UNITED STATES
NUCLEAR REGULATORY COMMISSION
WASHINGTON, D. C. 20555
December 23, 1980

The Commission has issued the enclosed Amendment No. 33 to Facility Operating License No. DPR-71 and Amendment No. 54 to Facility Operating License No. DPR-62 for the Brunswick Steam Electric Plant (BSEP), Unit Nos. 1 and 2, respectively. These amendments consist of changes to the Technical Specifications in response to your application dated November 5, 1980.

The amendments revise the Technical Specifications to provide a one-time extension of certain surveillance intervals to allow the required testing to be performed during a Brunswick Unit 1 outage scheduled for Spring 1981. The request for extension of the 6 month interval for snubber visual inspections was not adequately justified on a risk assessment basis and could not be granted. This issue was discussed with members of your staff who agreed that adequate justification for extending the snubber visual inspection interval could not be developed in sufficient time to support the request. The remaining tests are on 18-month intervals and are normally performed during a refueling outage. Small extensions for these tests were justified and a

Figure 3.1.5

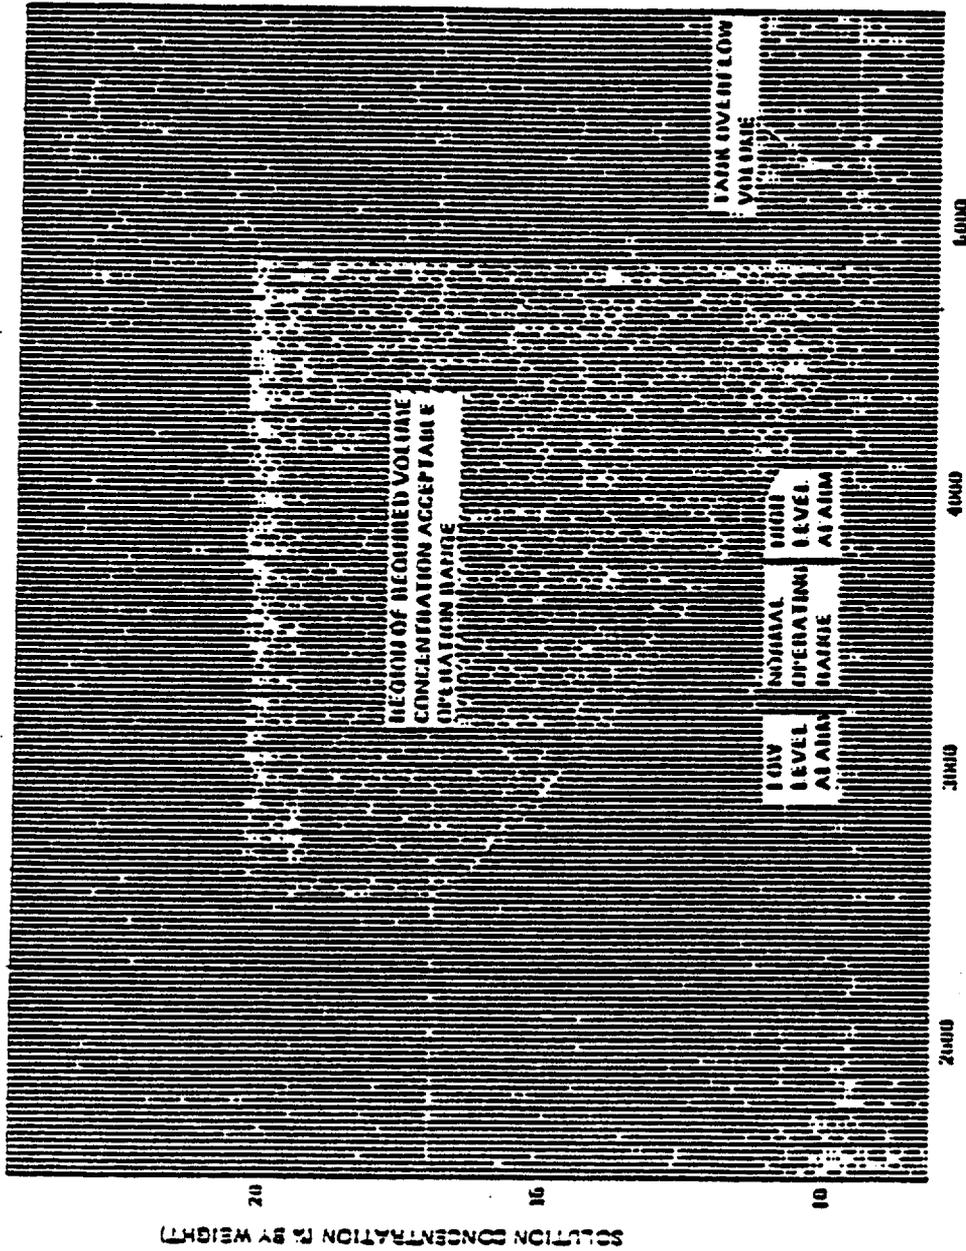
- c. At least once per 18 months during shutdown by;
 - 1.* Initiating one of the standby liquid control system loops, including an explosive valve, and verifying that a flow path from the pumps to the reactor pressure vessel is available by pumping demineralized water into the reactor vessel. The replacement charge for the explosive valve shall be from the same manufactured batch as the one fired or from another batch which has been certified by having one of that batch successfully fired. Both injection test loops shall be tested in 36 months.

- 2.* Demonstrating that the minimum flow requirement of 41.2 gpm at a pressure of 1190 psig is met.
 3. Demonstrating that the pump relief valve setpoint is 1400 ± 50 psig.

*For the performance of this surveillance scheduled to be completed by February 25, 1981, a onetime-only exemption is allowed to extend this surveillance until "before the completion of the Spring 1981 outage," scheduled to commence in March, 1981.
